**COMMENT RESPONSE PREPARED APRIL 20, 2022, BY THE CONSULTANT TEAM.**

**Re: Second Submission Review** – Waterstone Site Plan No 4 – Site Plan and Plat  
Application Number: **DA-1758-10**  
Case Numbers: **2021-4016-00**

# WATERSTONE SUBDIVISION FILING NO. 4

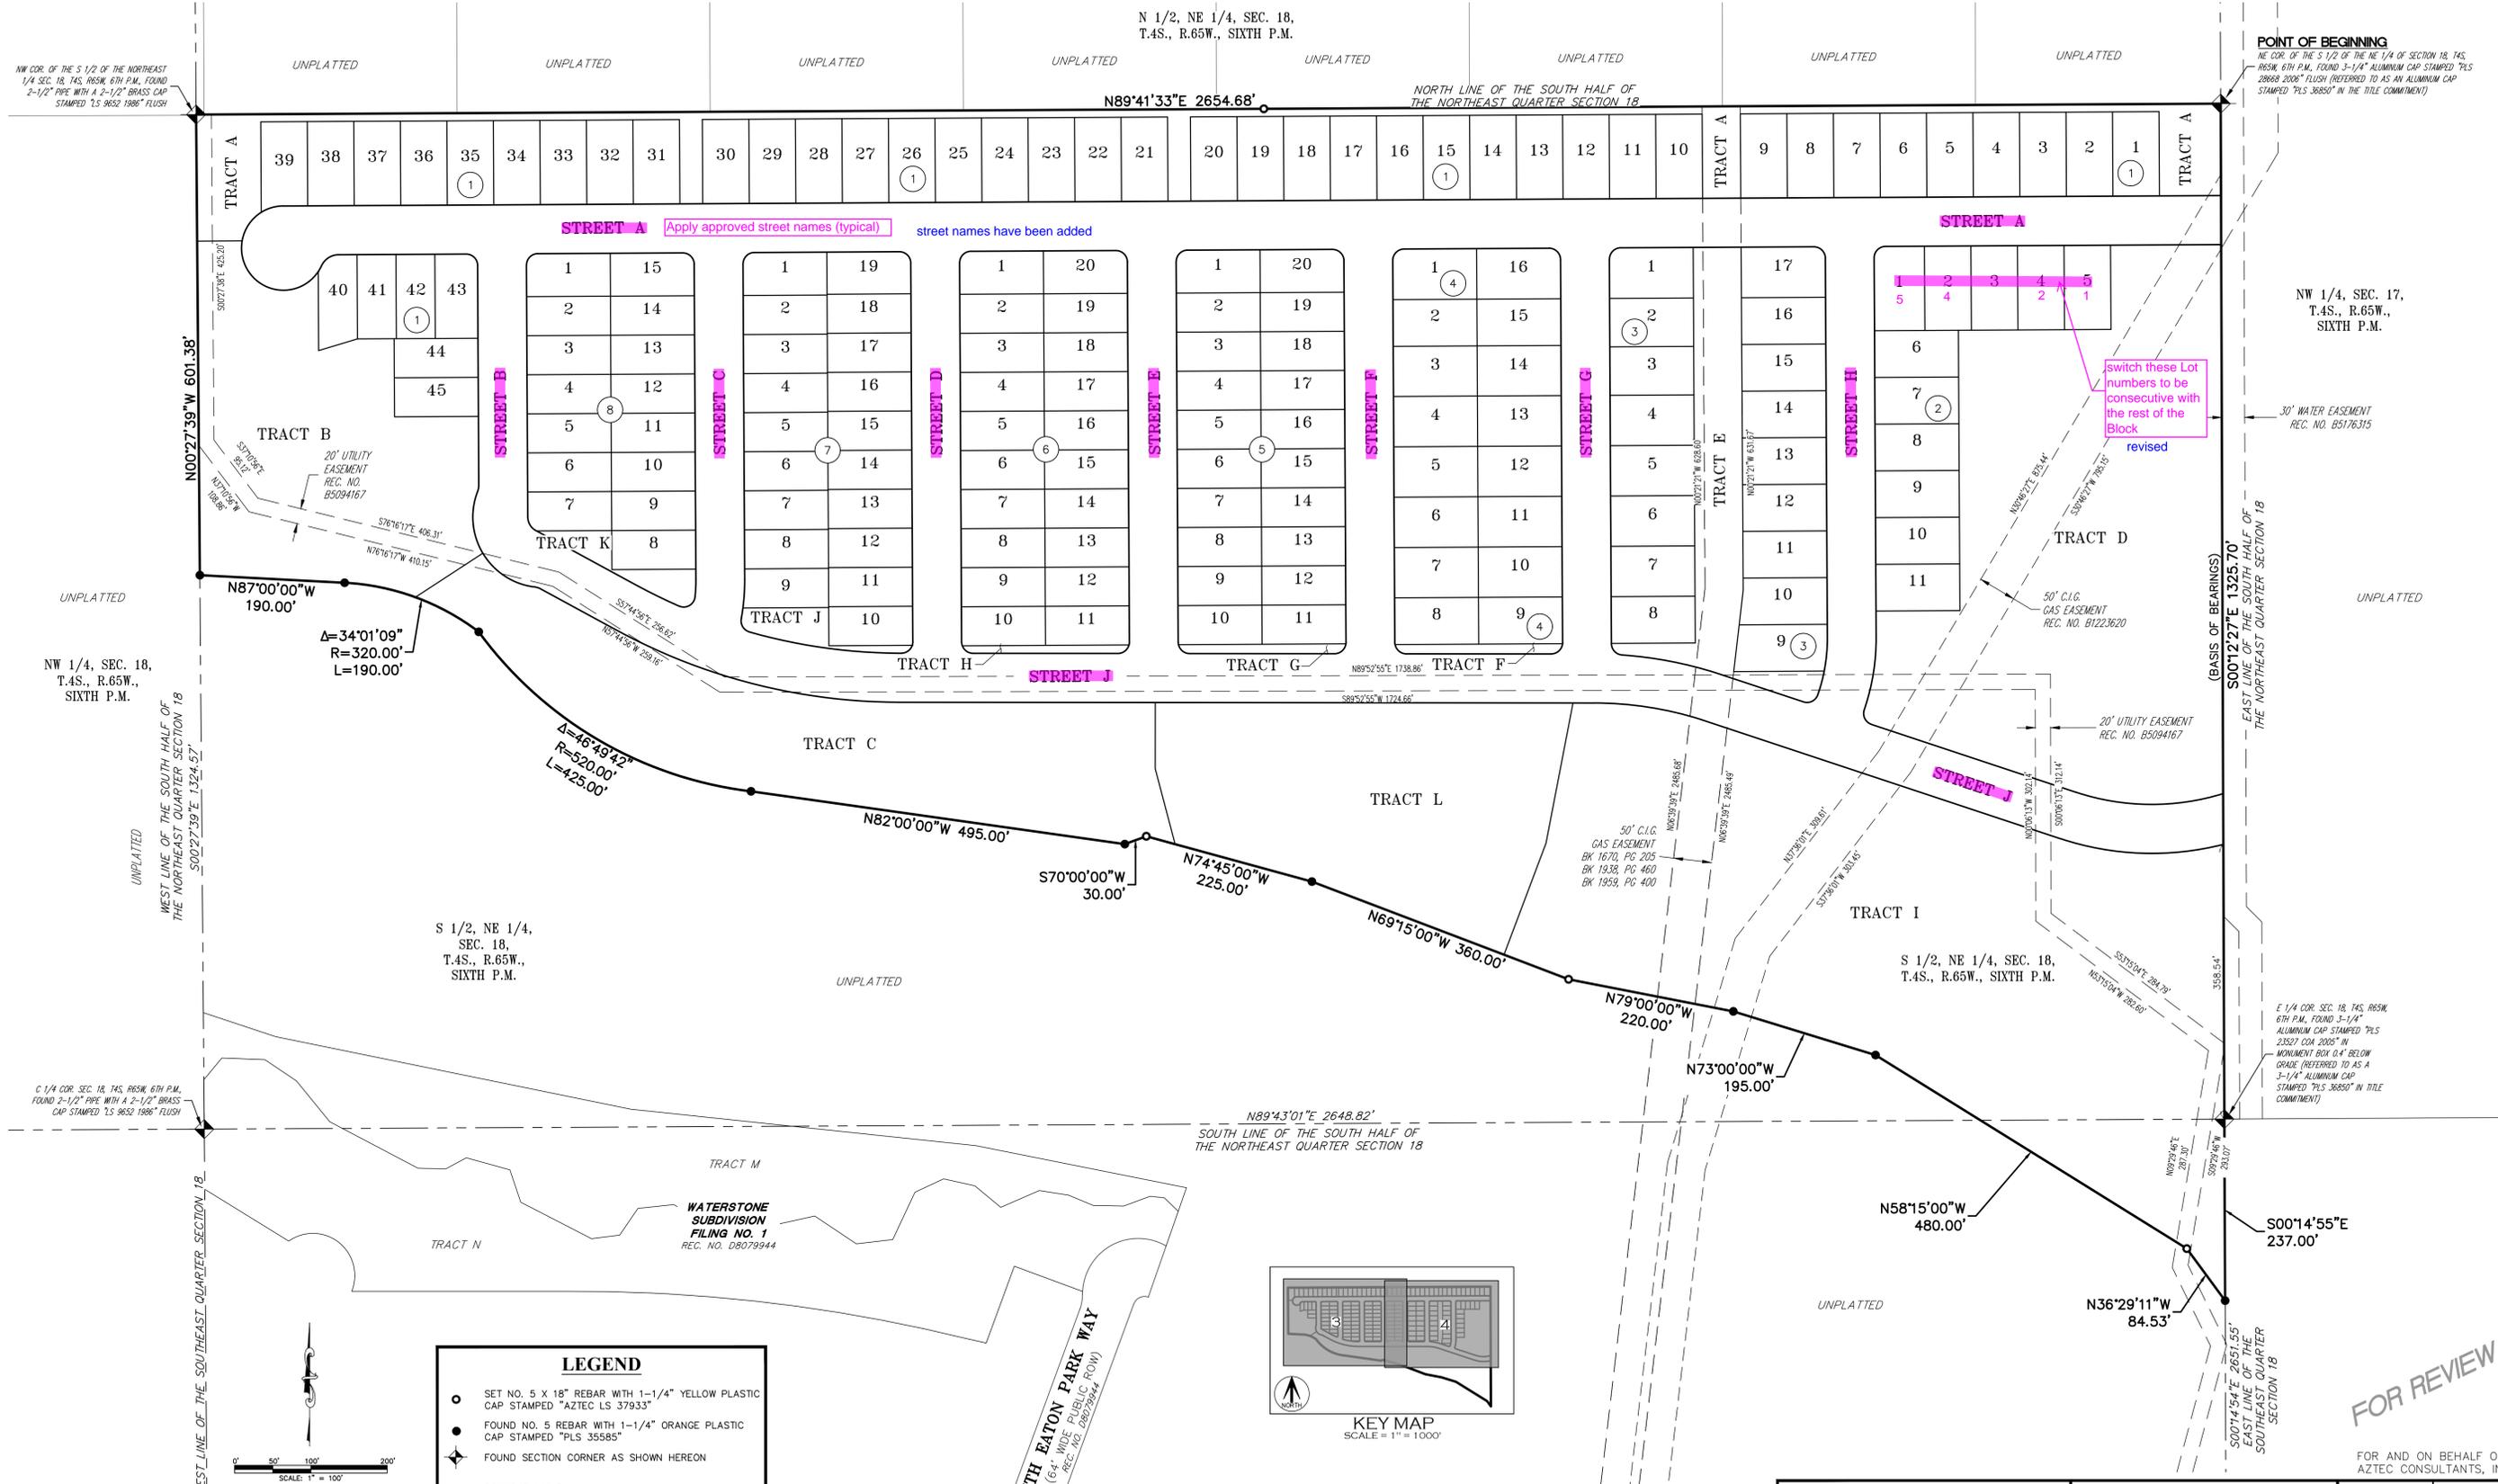
12Q. Correct to say "situated" in the legal description. Please also correct formatting noted on the sheet.

12R. Add the full stamping on the cap - match the State Monument Record.

12U. Make corrections in the final statement of the legal description to add "and". Only add this when the Tracts are being dedicated to the City by this plat (delete).

- Response: Corrected.**
- 12V. Replace with the actual street names and any other streets that may apply in Note 9.  
**Response: Street names added.**
- 12W. Delete the County signature block.  
**Response: Deleted.**
- 12X. Delete the Site Plan notes that should not be included on the plat.  
**Response: Deleted.**
- 12Y. Add the owner's name - match the Title Commitment.  
**Response: Added.**
- 12Z. Correct spelling to "GUARANTY"  
**Response: Corrected.**

NOTICE: PER THE STATE OF COLORADO BOARD OF LICENSURE FOR ARCHITECTS, PROFESSIONAL ENGINEERS, AND PROFESSIONAL LAND SURVEYORS RULE 1.6.B.2 THE WORD "CERTIFY" AS USED HEREON MEANS AN EXPRESSION OF PROFESSIONAL OPINION AND DOES NOT CONSTITUTE A WARRANTY OR GUARANTEE. EXPRESSED OR IMPLIED, THE SURVEY REPRESENTED HEREON HAS BEEN PERFORMED BY ME OR UNDER MY DIRECT SUPERVISION IN ACCORDANCE WITH APPLICABLE STANDARDS OF PRACTICE AND IS BASED UPON MY KNOWLEDGE, INFORMATION AND BELIEF. GUARANTY revised
